REMARKS

Serial No. 09/751,820 MARKED UP COPY TO SHOW CHANGES MADE

20. (Amended) A battery terminal connecting cable comprising:

Fig. 1

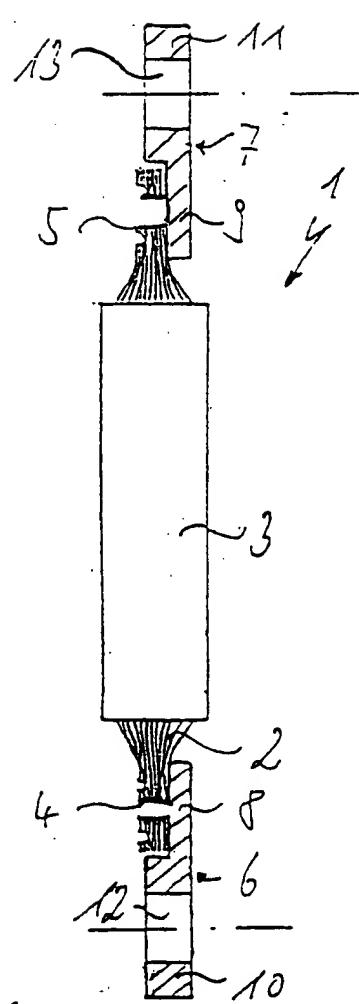
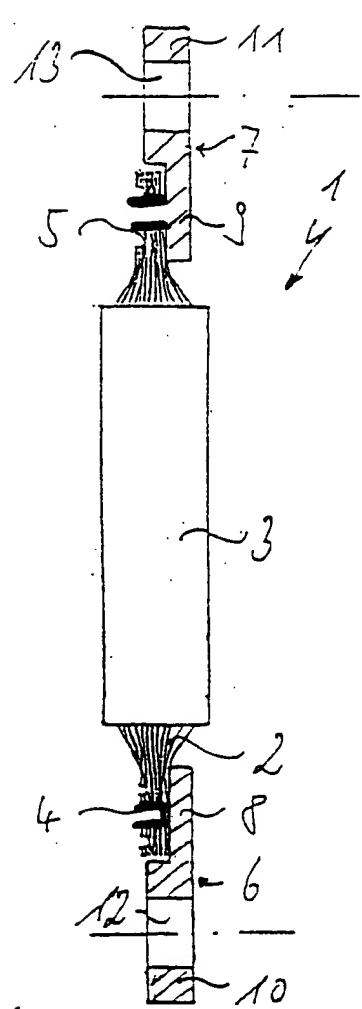
The Examiner has objected to the drawings. FIGS. 1-3 have been amended to overcome this rejection.
